DRAINAGE AND TRANSPORTATION INFORMATION SHEET

RE: GOLF COURSE + WESTSIDE COMMERCIAL SUBDIVISION
10850 GOLF COURT RD. NW
ENGINEER'S STAMP DATE: 9/14/22
HYDROLOGY FILE: A12D008B2

Per the correspondence dated October 11, 2022, please find the following responses addressing the comments listed below:

DRAINAGE REPORT FOR

Figure 5 – Developed Basin Map

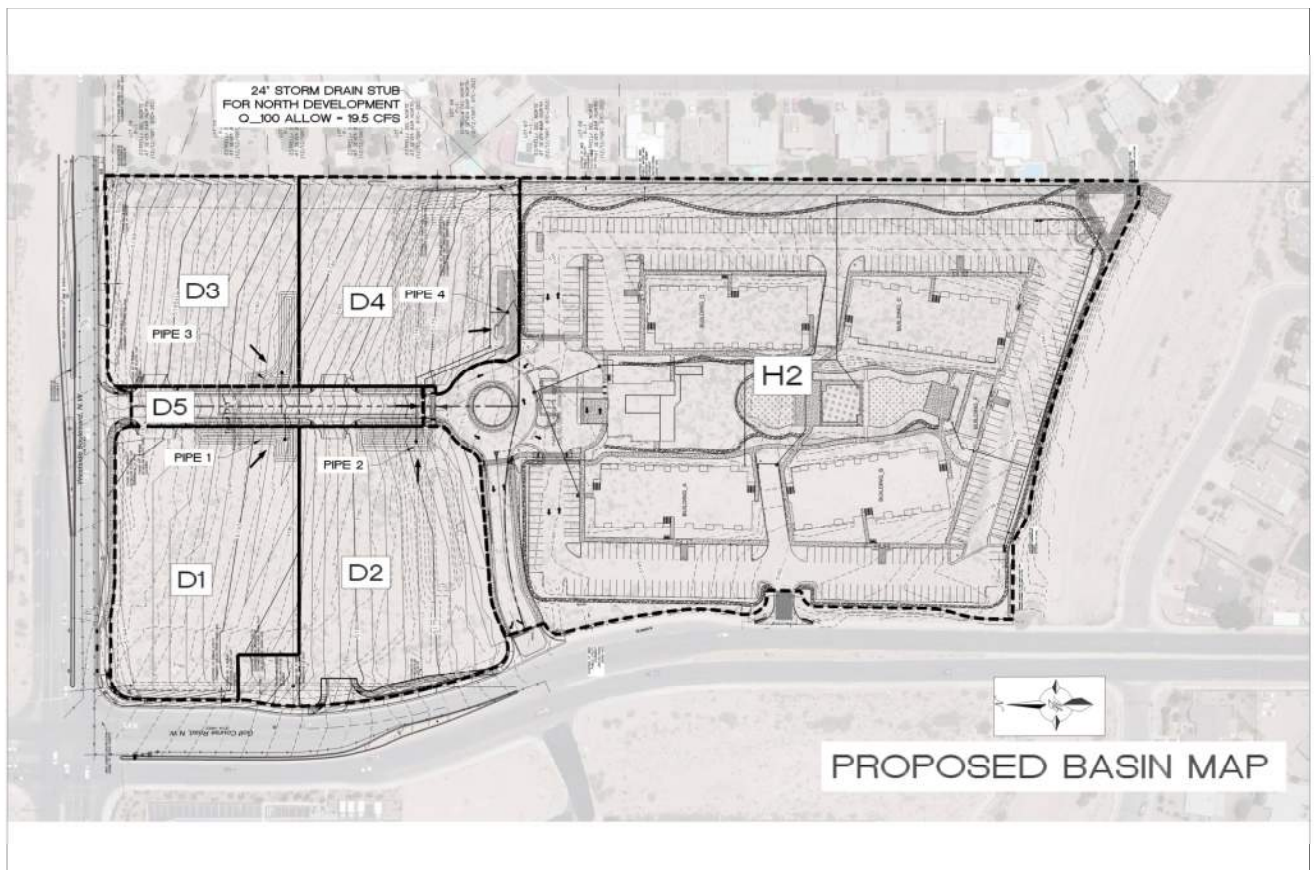
7. The drainage basin boundaries need to match the grading. Presently the basin boundaries are on the lot lines, thus indicating that there will be no cross-lot drainage and that each lot drains to its own pond and then into the common storm drain system. However, the grades show the west portion of basin D1 drains into D2 and not into Pond 1. The west perimeter slopes drain to offsite, and the south side of each lot has some slope drainage across the lot line. Identify how cross-lot drainage will be prevented or identify cross-lot drainage easements with beneficiary and maintenance.

RESPONSE: Drainage basins updated.

CONCEPTUAL GRADING &
DRAINAGE PLAN

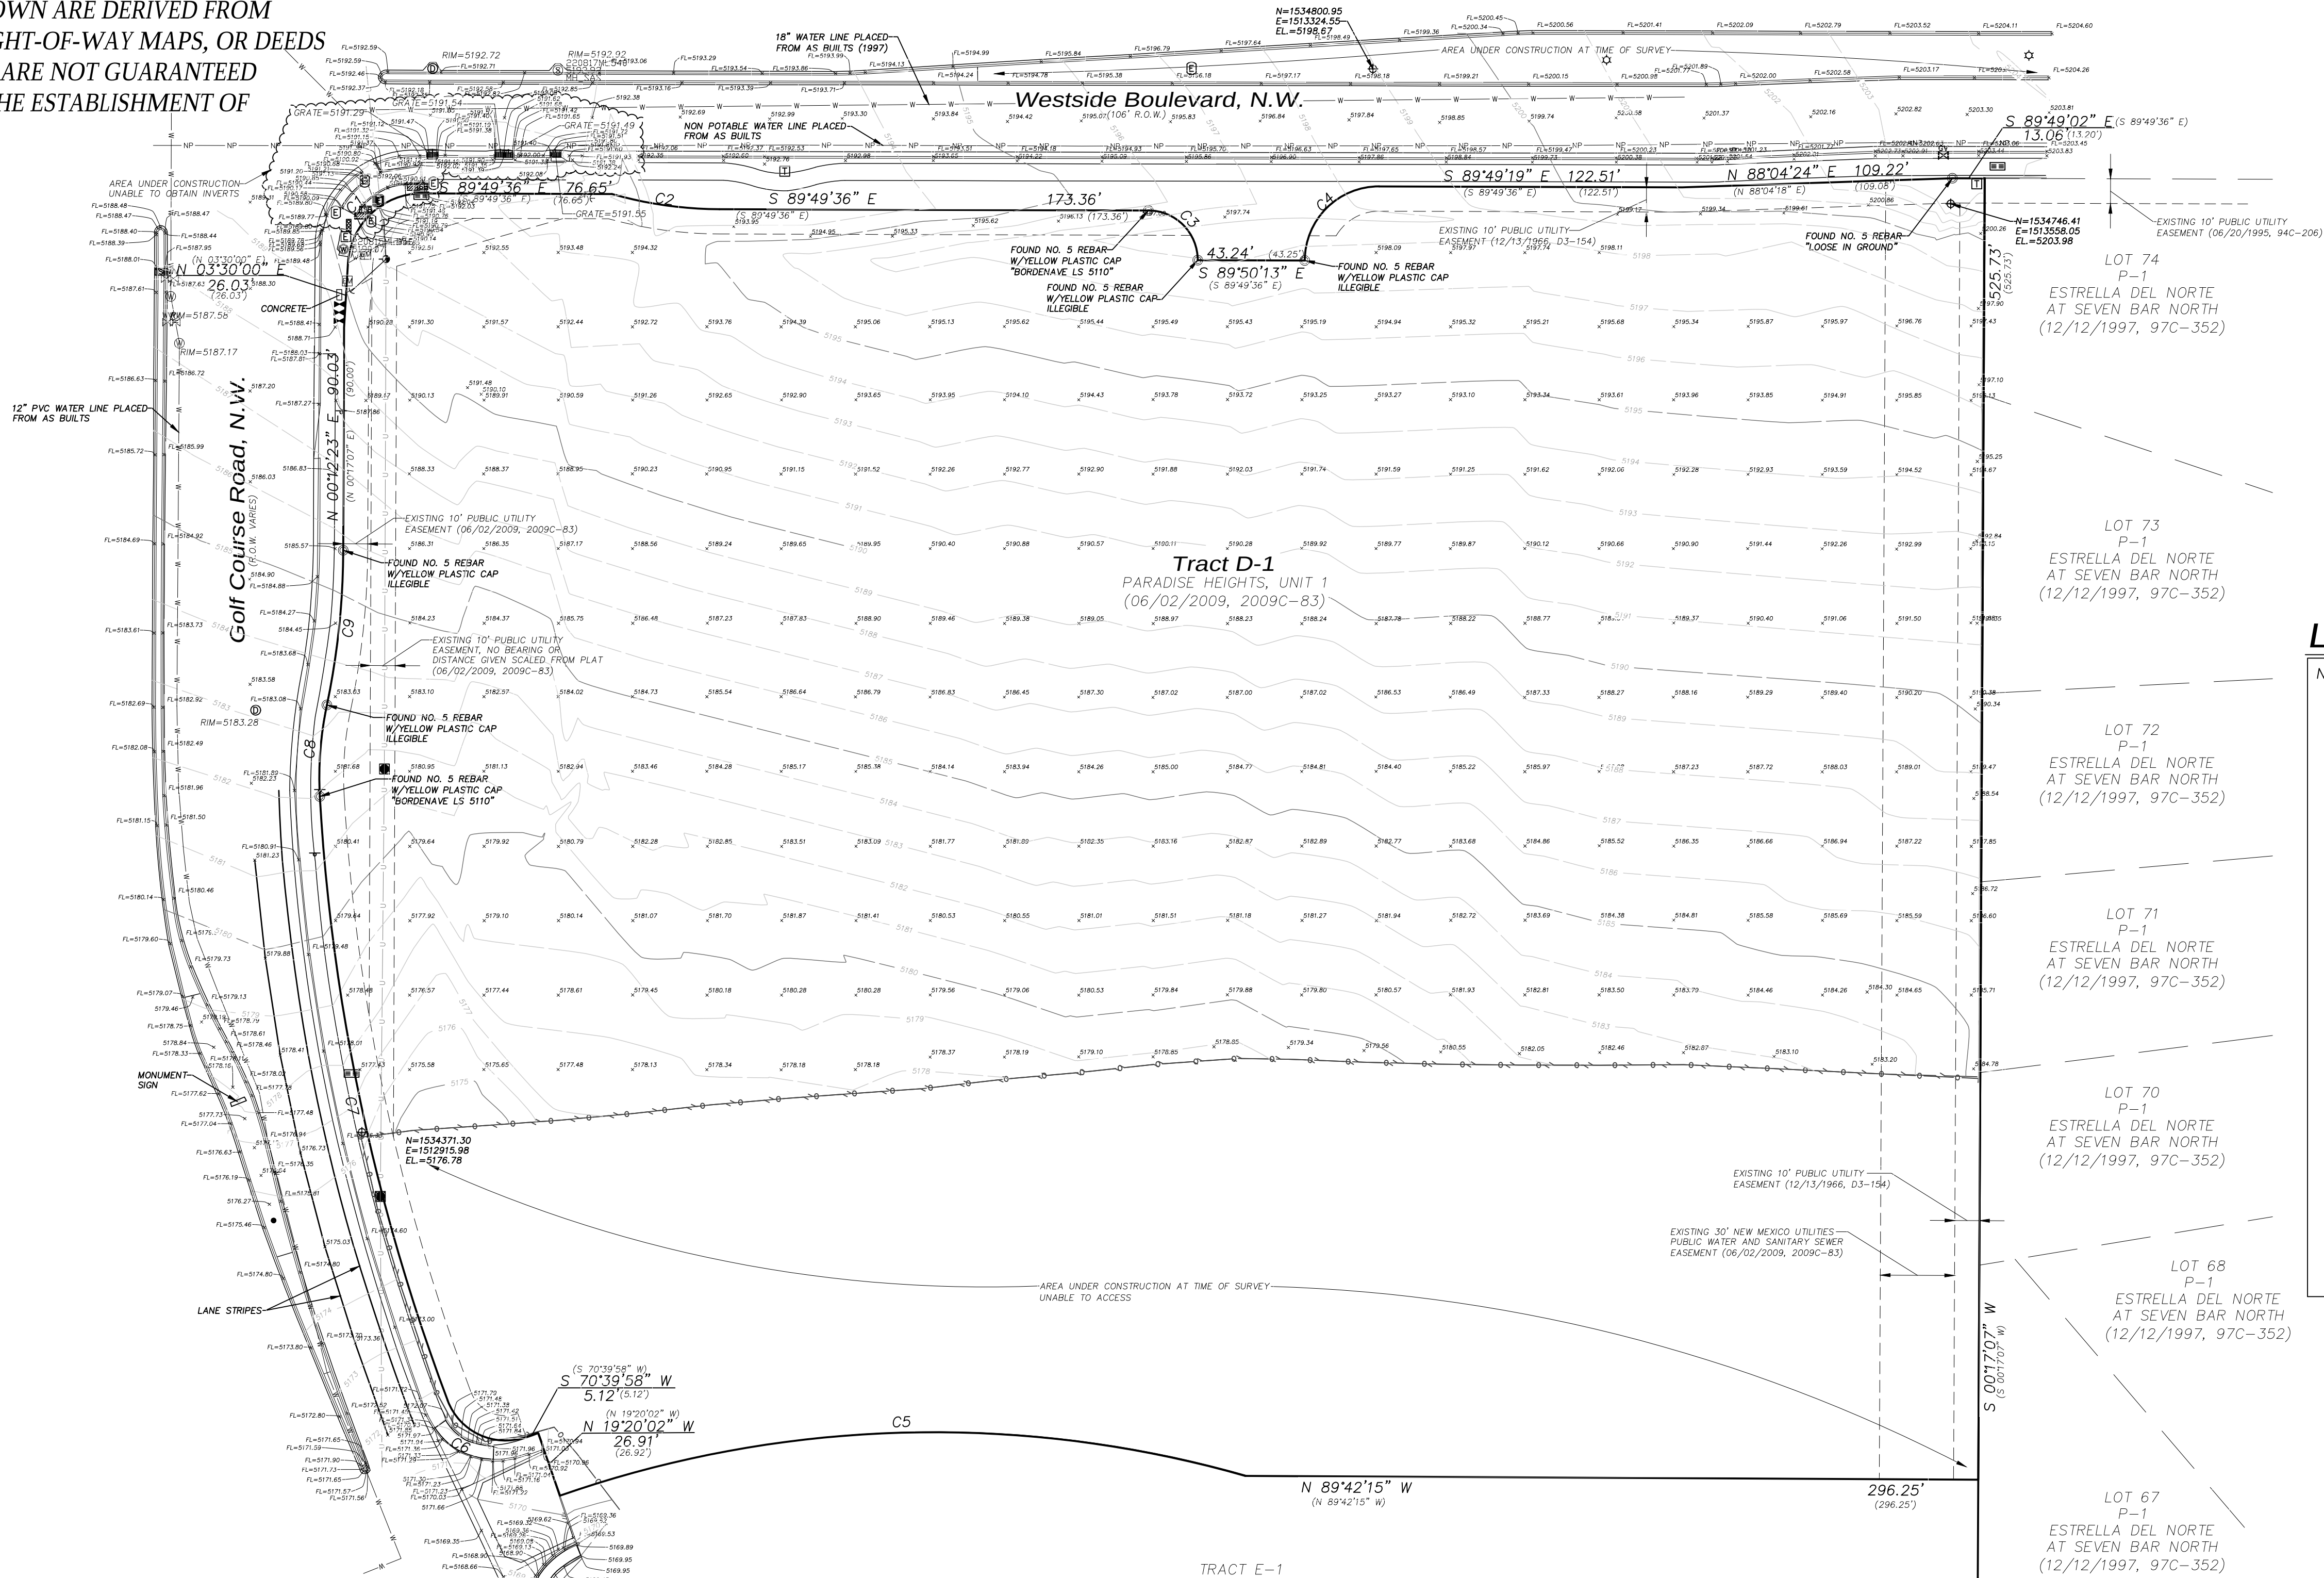
10. Provide sections through all external boundaries showing proposed retaining walls, garden wall, property/ROW lines, and existing and proposed grades. In accordance with DPM Ch.22, section 5 part B, grading and wall construction near the property line may not endanger adjacent property or constrain its use.

RESPONSE: This is referencing an old version of the IDO, and this is a conceptual drainage management plan. Final design may vary.

Topographic Survey Of
Tract D-1
Paradise Heights, Unit 1
Section 1, Township 11, Range 2, N.M.P.M.
Albuquerque, Bernalillo County, New Mexico
October 2022

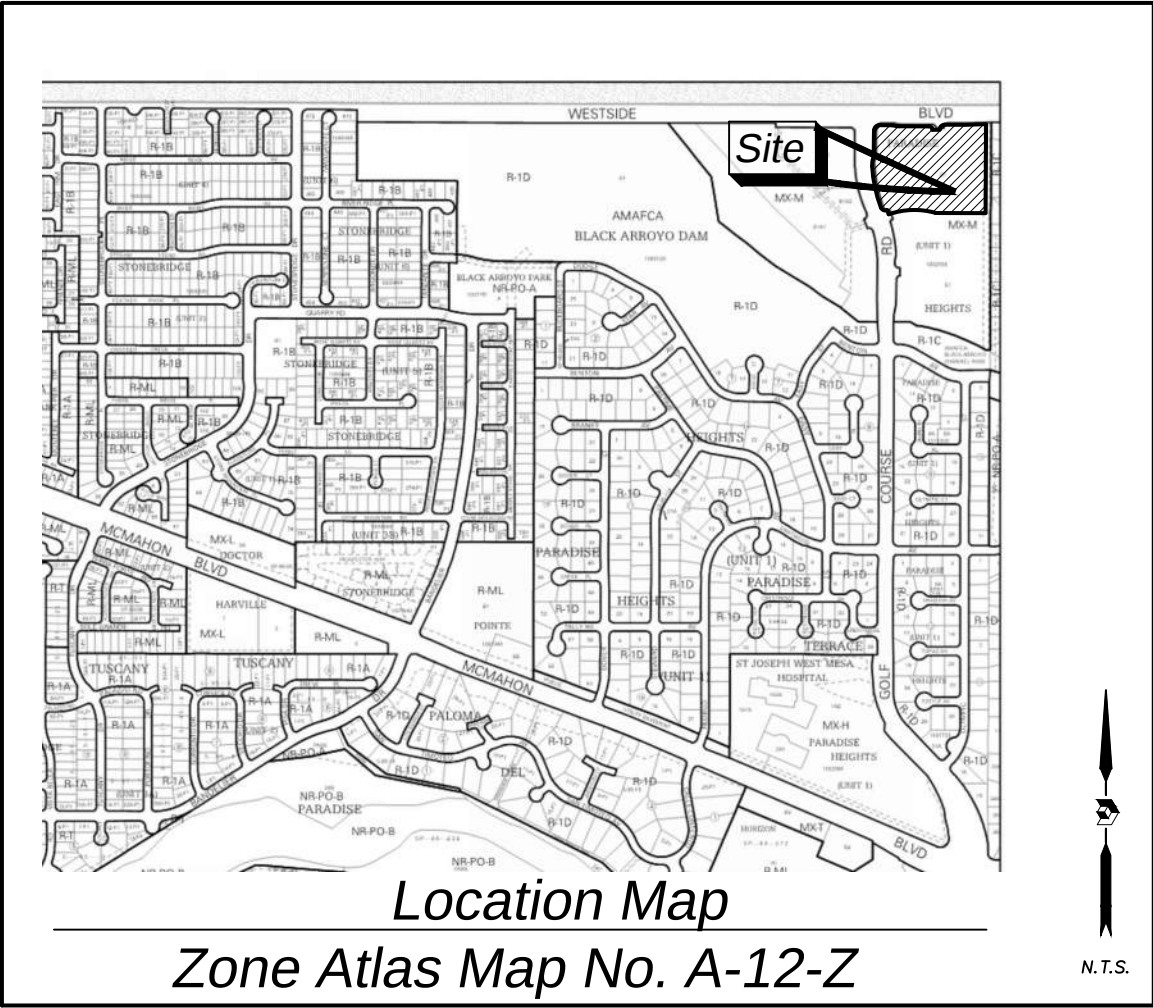
9. Please provide the Benchmark information (location, description, and elevation) for the survey contour information provided.

RESPONSE: Topographic survey added to end of drainage report.
